UNITED STATES PATENT AND TRADEMARK OFFICE

10/526,556

| Office Action Summary | Application No. 10/526,556 | Applicant(s) EVANS ET AL. | |

DETAILED ACTION

Drawing 1

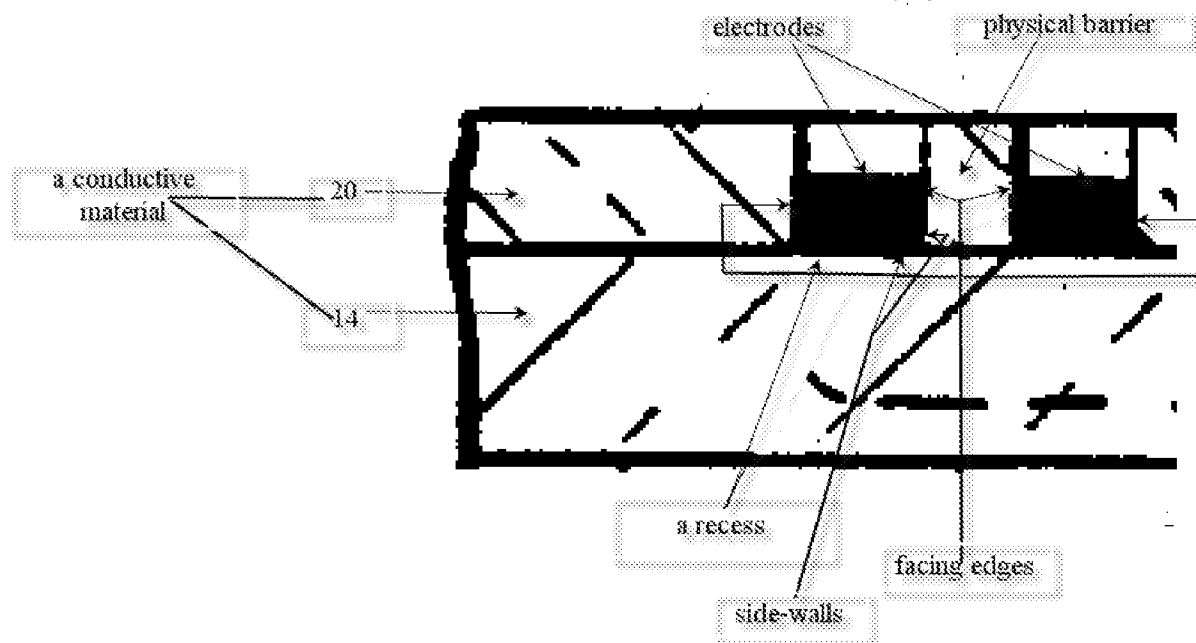
Respecting claim 1, Slayman discloses, in Figs. 1-2 or the Drawing 1 below, a photoconductive material (14 and 20) and a plurality of spaced apart electrodes (16, 18) provided on said photoconductive material, each electrode having at least one facing edge which faces a facing edge of an adjacent electrode, a physical barrier (col. 1 line 68) being provided abutting a facing edge of at least one electrode, said barrier extending to at least the full height of said facing edge. Slayman further discloses the facing edge of the at least one electrode is provided within a recess of the surface of said photoconductive material, said recess including side-walls formed from said photoconductive material, one of the side-walls of said recess providing said barrier.

Respecting claims 3-4, Slayman discloses the facing edges of adjacent electrodes are provided within recesses, such that the side walls of said recesses provides the barriers for both facing edges, and wherein said photoconductive material (20) is provided between said adjacent facing edges, and said sidewalls extend to at least the full height of said facing edge.

Respecting claim 5, Slayman discloses a capping material (portion of 20 on top of 16, 18) being provided over the electrodes (16, 18).

Respecting claim 10, Slayman discloses the electrodes (16, 18) are provided on a planar surface of said photoconductive material (14) and a capping material (a portion of 20) is provided on the facing edges of said electrodes such that said capping material forms said barrier.

Drawing 2

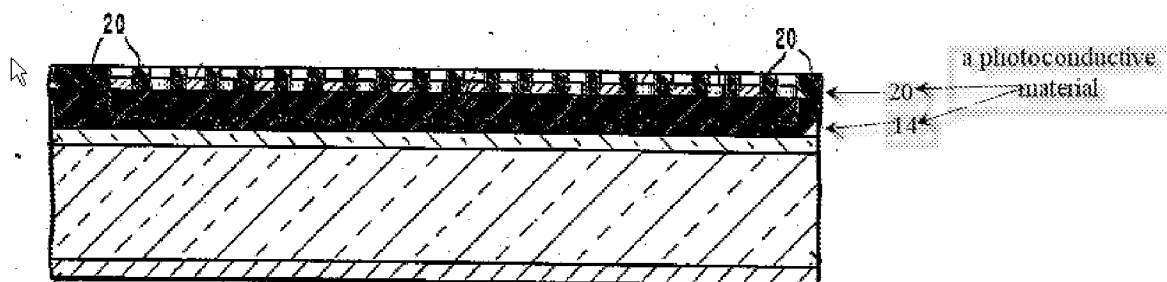
12. With respect to amended independent claim 1, Applicant argues Slayman does not disclose a claimed features of “the side-walls of the recess providing the recited barrier are formed from said photoconductive material” since Slayman discloses that **the barrier is formed by a different passivation layer** that is separate from and that has different properties **than the active layer 14**. The Examiner respectfully disagrees. Claim 1 recites “the side-walls of the recess formed **from a photoconductive material, a side -wall of the recess providing said barrier**” which is not exclusive the photoconductive material from being formed from different layers. Therefore, layers 14 and 20 of Slayman reads on a photoconductive material as claimed. In other words, Slayman clearly discloses, in Fig. 2 of Slayman or the best seen in the above Drawings 1 and 2, **the side-walls of the recess formed from a photoconductive material, wherein a side-wall of the recess providing said barrier** as claimed.

Since Slayman discloses every features of the claimed invention, the 102 rejection of claim 1 is proper.
